TABLE 3.6.3-1

PRIMARY CONTAINMENT ISOLATION VALVES

FIGURE I HIGH PRESSURE COOLANT INJECTION

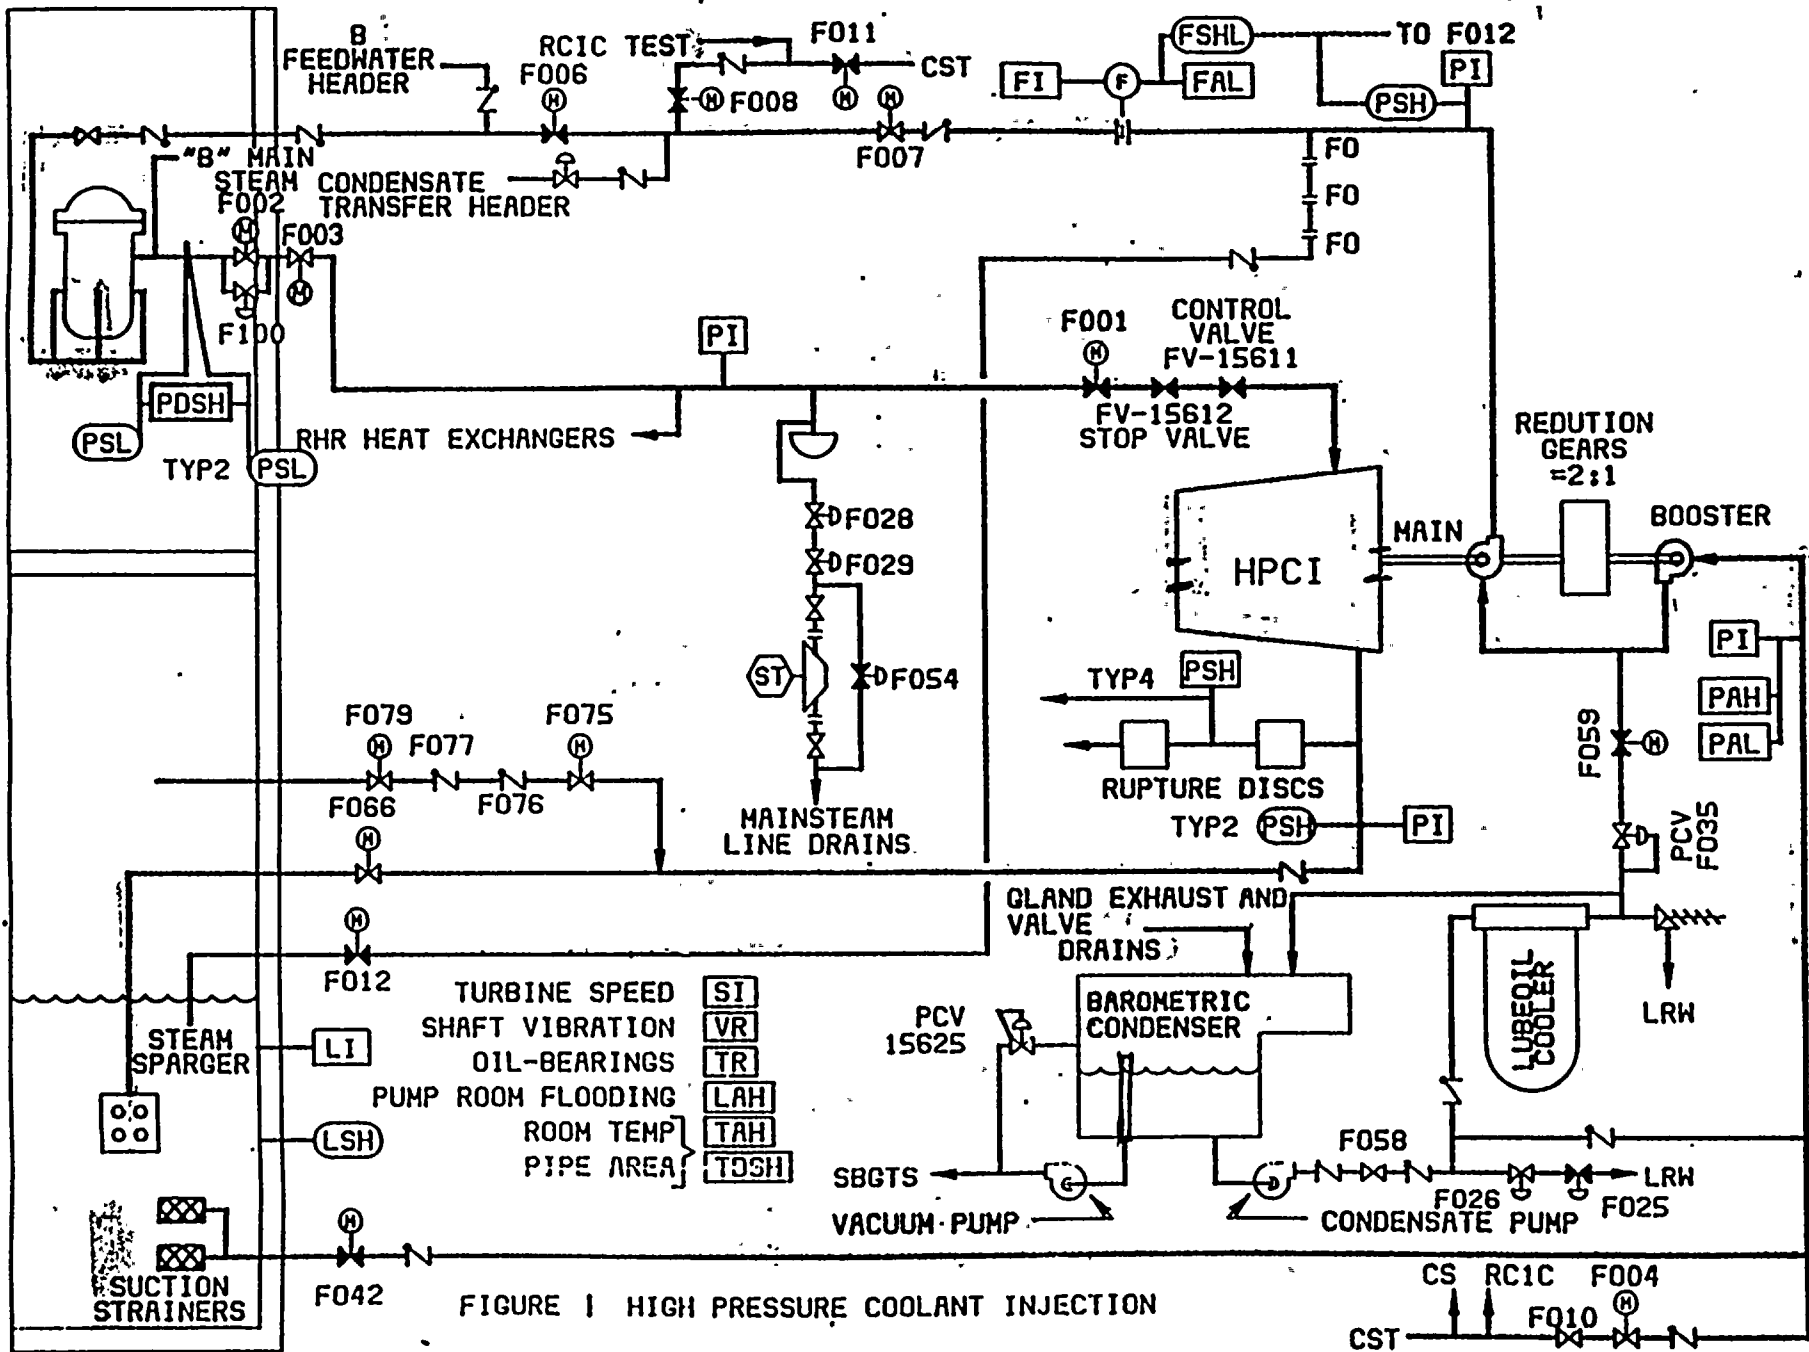
\* The HPCI HV-155 F002 valve may be considered OPERABLE with its current minimum torque switch setting for the period beginning May \_\_, 1987 until an outage of sufficient duration to revise the setting occurs.
